RECEIPT DATE: 8/5/14 **ONSITE SEWAGE DISPOSAL SYSTEM** P SS4568

PROPERTY ADDRESS: 11775 Chapel Estates Drive

SUBDIVISION: Chapel Rise LOT: 9 TAX ID: 05-594208

**BAT SEPTIC PROFILE
CHAPEL RISE**
LOT 9
ZONED RC-DEO PLAT NO. 22022
TAX MAP NO.: 29 GRID NOS.: 8 & 14
5TH ELECTION DISTRICT HOWARD COUNTY, MARYLAND
SCALE: AS SHOWN DATE: OCTOBER, 2013
SHEET 2 OF 2

See As-Built Drawing
On Separate Sheet

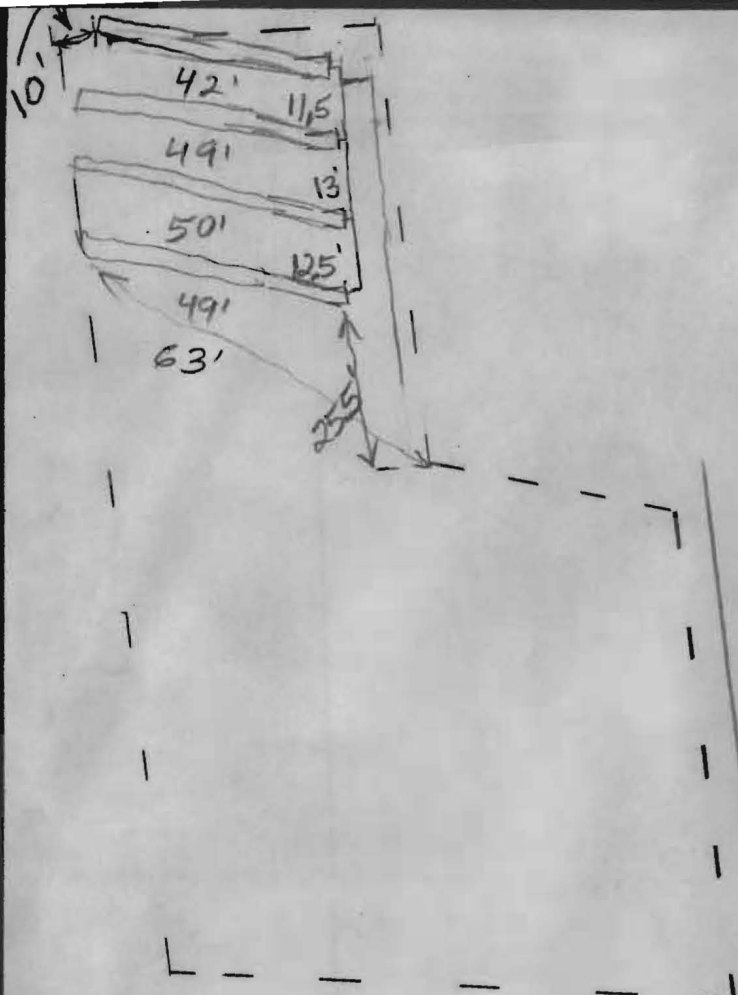
9/3/2014 Trench locations are similar to plan. BAT unit needs to be moved further from house out of driveway grading area. Told installer that he would probably need a 2 H.P. pump if using a 2" force main. (BB)

11/5/2014 Pump and alarm working. Three feet plus of head in turn-ups increasing with downhill progression. Valve wide open. (BB)

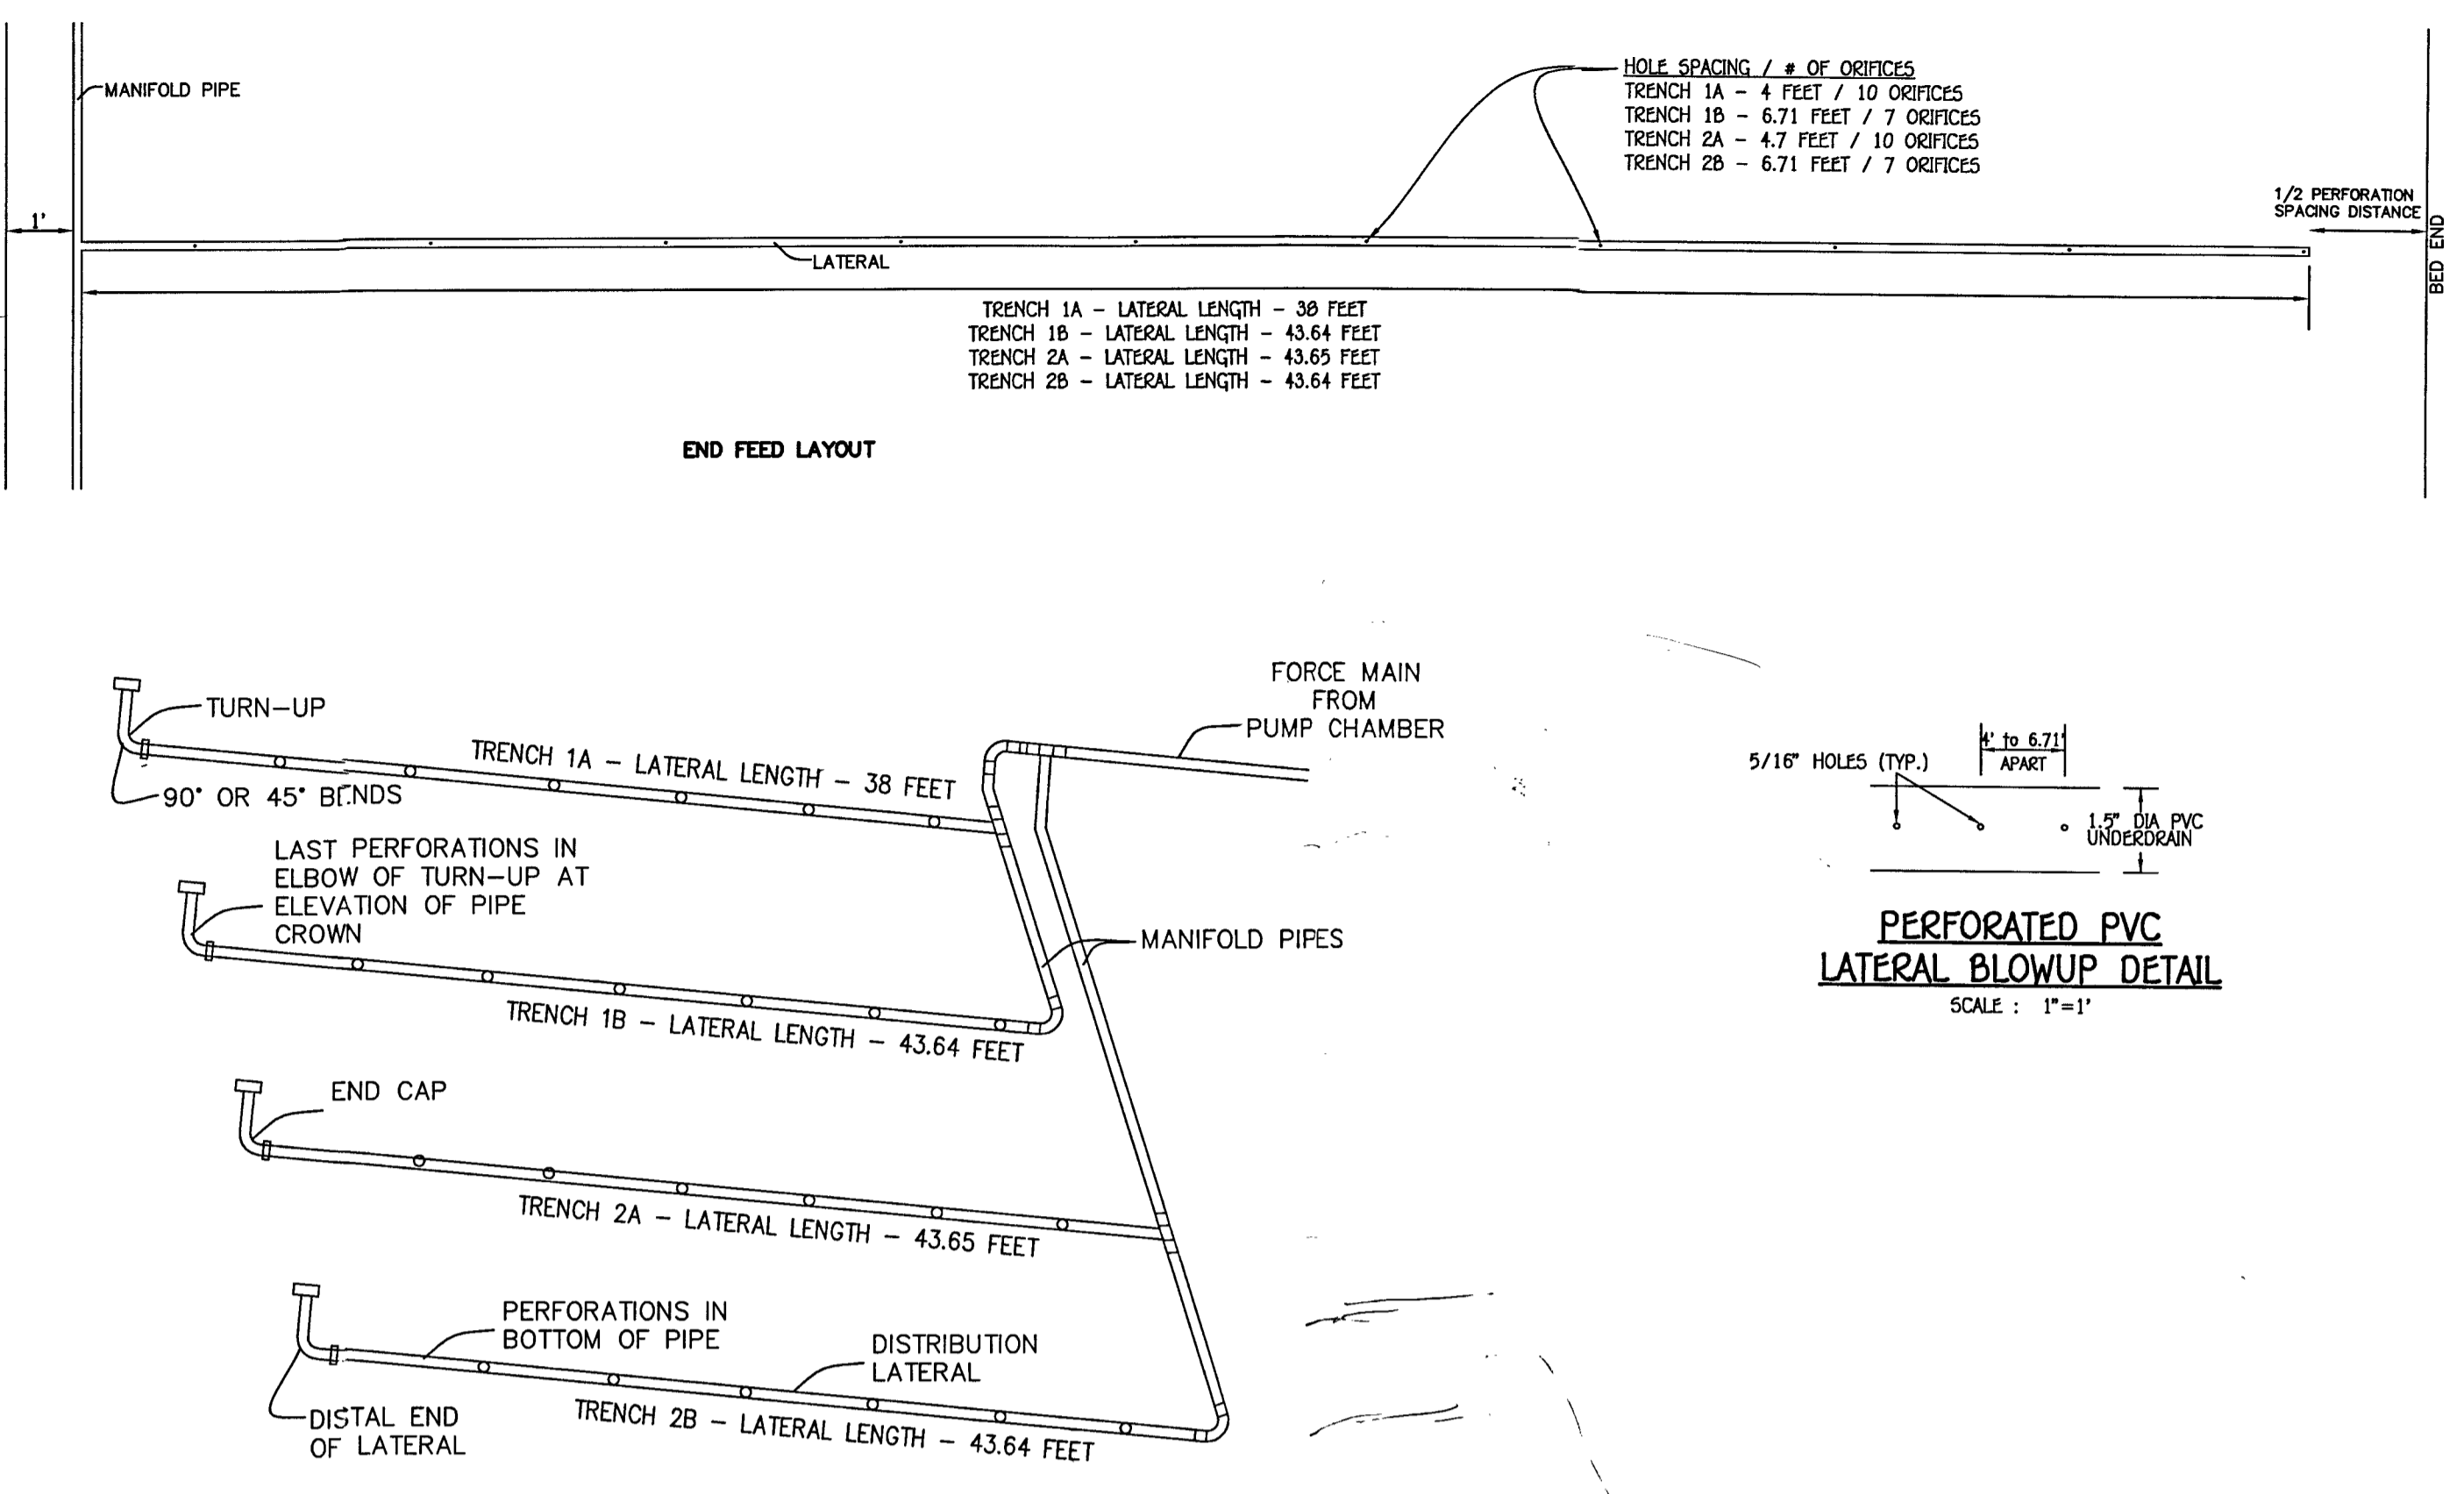
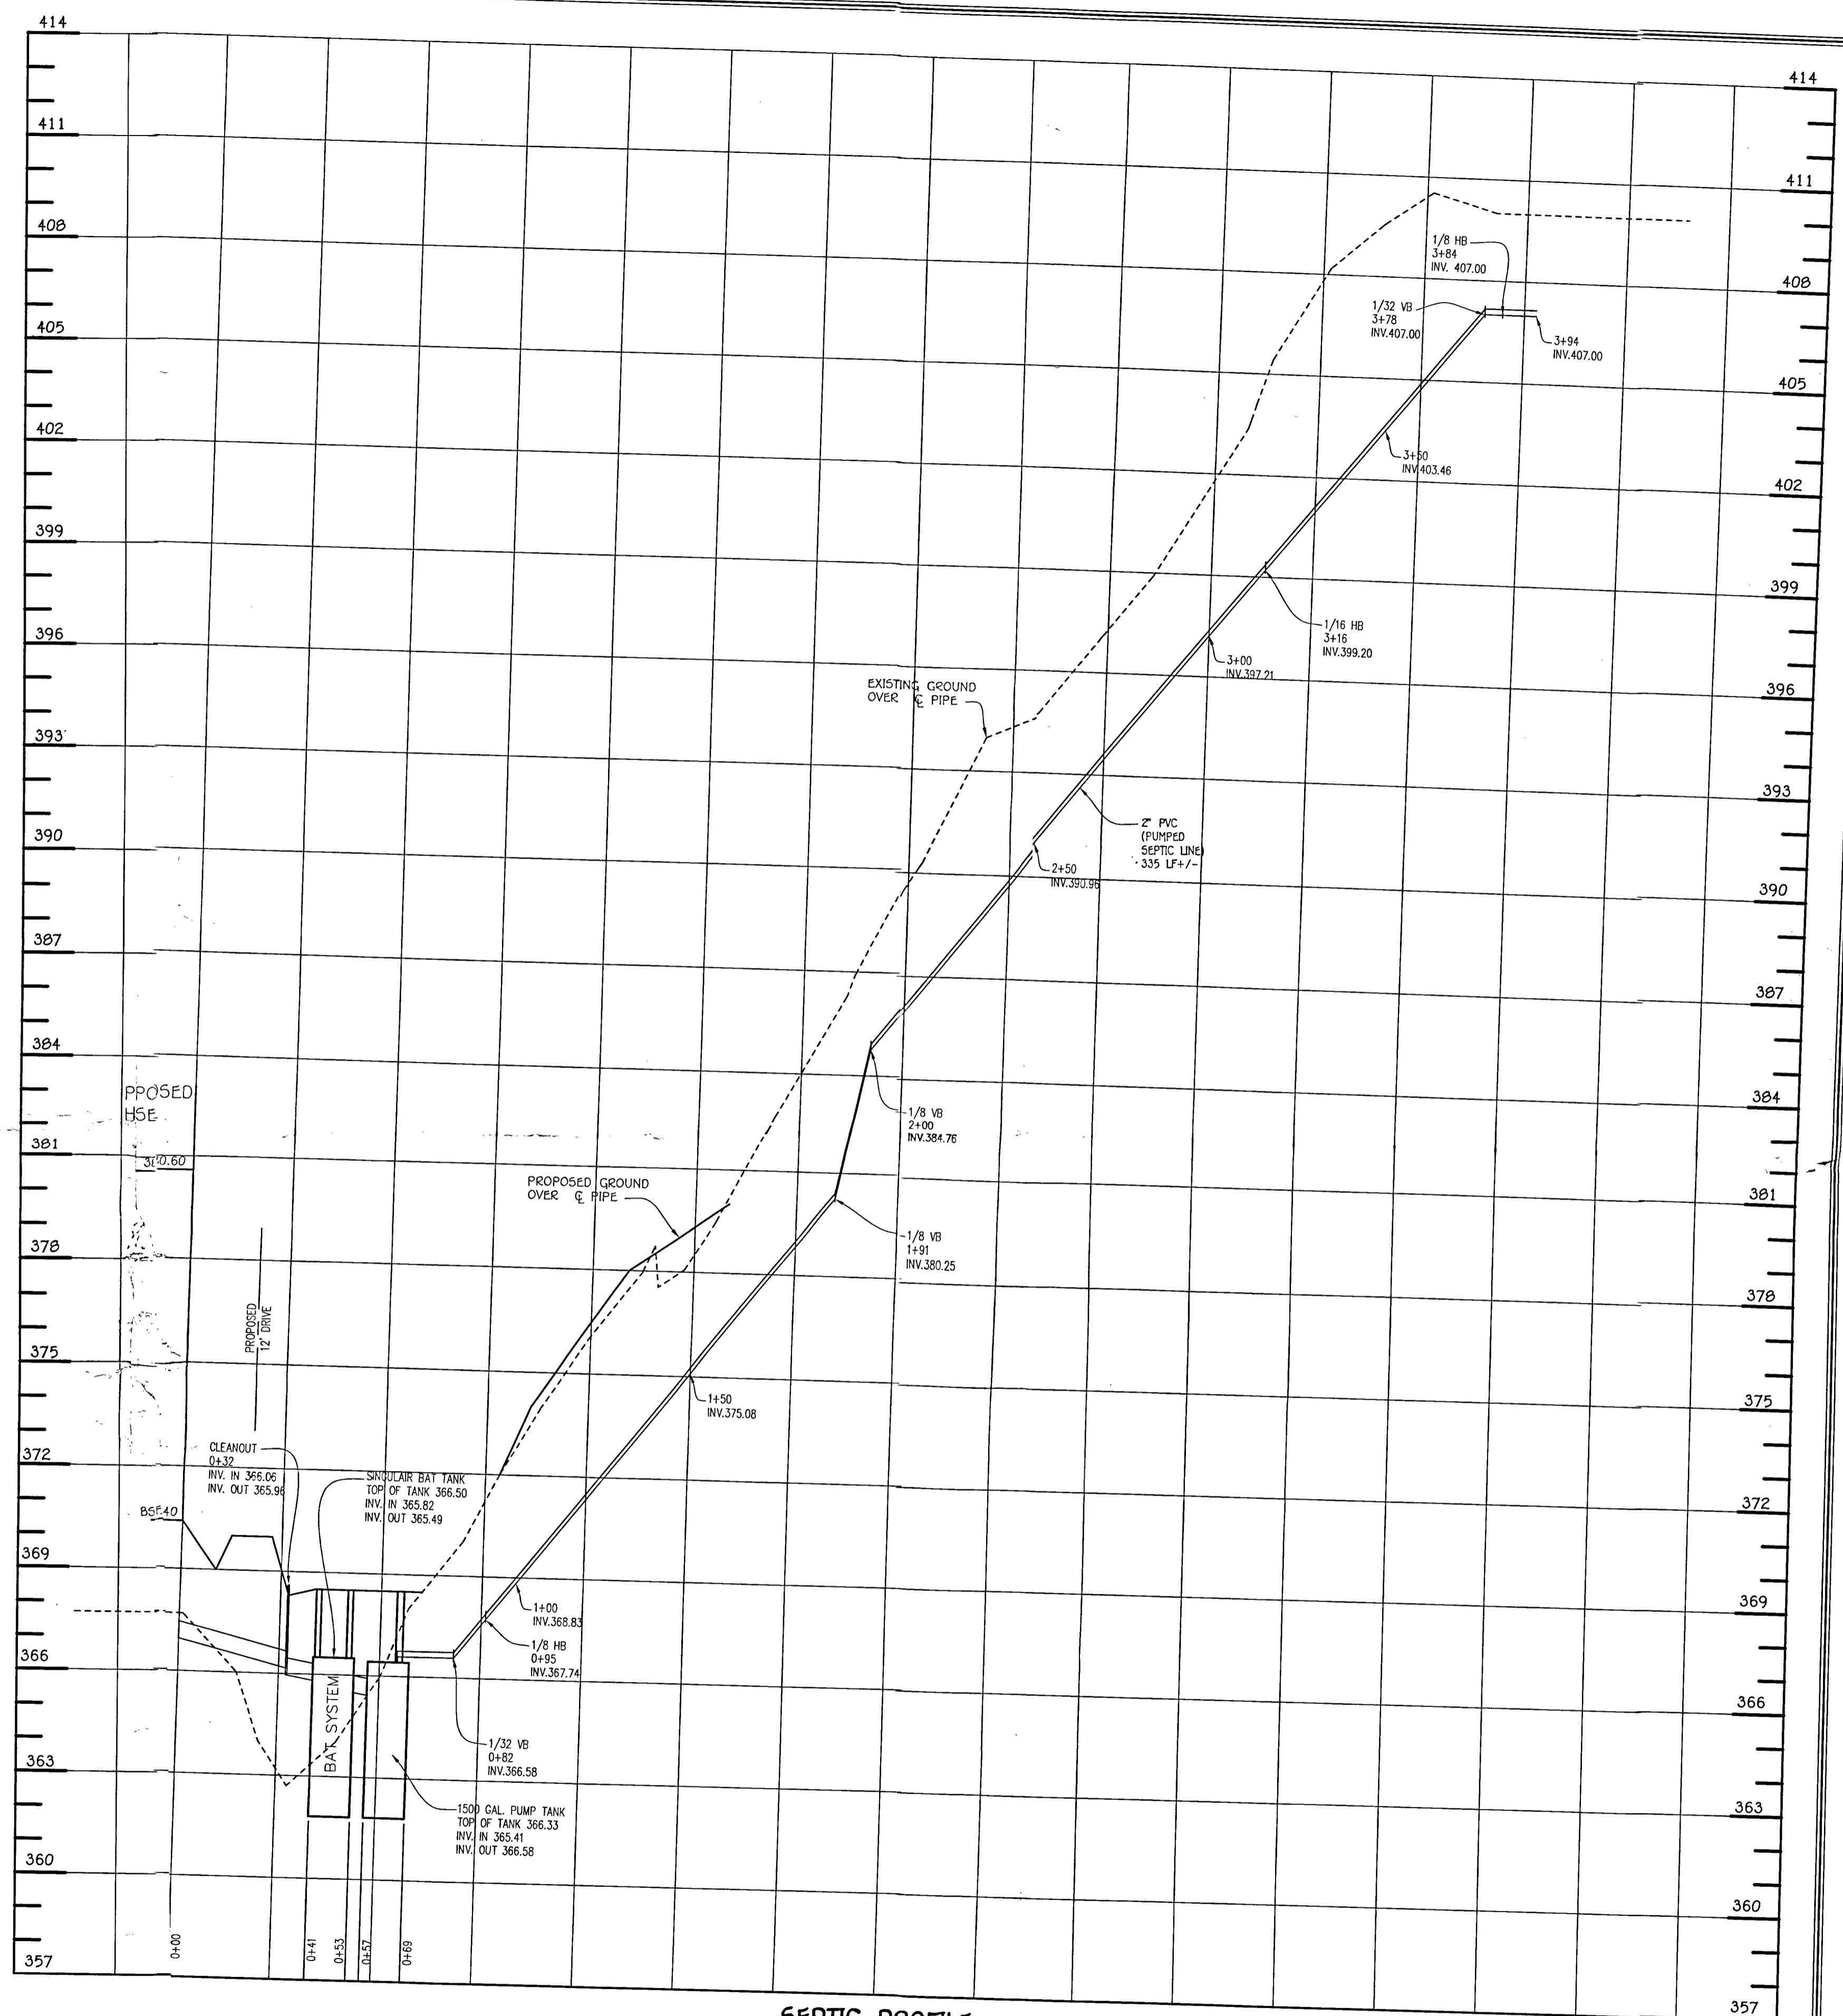
I just reviewed it today. I can't remember what we decided previously regarding the valve, but you are showing it on the septic profile and the larger site plan, but not on the distribution detail or accounting for it on the friction loss. We are fine with not using a valve at all, just get rid of it on the profile and the site plan on page 1.

Also, I did not pick up previously that the design dose you are using is 4x laterals plus fm volume. The dose should be 5x lateral volume plus fm and manifold volume or 1/6 design flow, whichever is greater. In this case, the 5 bedroom home is $750/6 = 125g$. But, you have a total lateral length of $170' \times 5 \times 0.106 = 90g + 64g$ fm volume = 154g. Your dose should be 154g.

Also, I cannot read any of the Gould's pump content or the pump tank content. It is really fuzzy.

We need to see your marks on the pump curve intersecting 58' head and 64gpm and clearly indicate which pump model you're choosing based on that. The pump tank needs to be a 1500g tank and we need to see the floats set and volume indicated so that the dose is 154g and that there is at least 750g worth of emergency storage space between the alarm float and the inlet invert of the tank.

Also, revise page 1 to indicate a 1500g pump tank and make sure the pump requirements note is accurate.

Finally, the perforated pvc lateral detail should be expanded to show the entirety of all four laterals with the perforation locations, size, and distances in between.

- A blowup of the disposal area showing details of the valves, feeder lines, and laterals
- A diagram of the lateral network showing the orifice locations with spacing noted in inches as well as the pipe diameter and orifice diameter
- A diagram of the lateral turnup with last orifice on the crown
- A notation of the exact pump model chosen that fits with the design criteria
- A detail on the pump chamber showing a ¼" weep hole in the line out that drains into the tank after pump shutoff.

Ok. Now I see where I was getting confused by your numbers. What we want is for the spacing to be half distance from the manifold to the first perf, then full distance for all the rest including the last spacing on the turnup crown. Then, there should be half spacing between the end of the lateral and the end of the trench. So, on the 40' trench, the lateral will be 38' long at 10 perfs (40/10 minus half spacing) with the first perf being 2' from manifold, the following nine perfs at 4' spacing with the last perf on the crown 4' from the previous and the lateral ending 2' from the end of the trench at 38'.

On the 47' trench with 7 perfs, the spacing should be 6.71' with a lateral length of 43.64'. The first perf would be 3.36' and the lateral would end 3.36' short of the 47' trench at 43.64'. With your 7.2' spacing in a 47' trench, 7.2x7 gives you a 50.4' trench. On the 47' trench with 10 perfs, the spacing would be 4.7' with 2.35' to the first perf and the lateral ending 2.35' short of the trench for a lateral length of 44.65'.

Trench 1A: 38' length 4' spacing 10 holes
Trench 1B: 45.5' length 7' spacing, 7 holes
Trench 2A: 45.125' length 4.75' spacing, 10 holes
Trench 2B: 45.5' length, 7' spacing, 7 holes
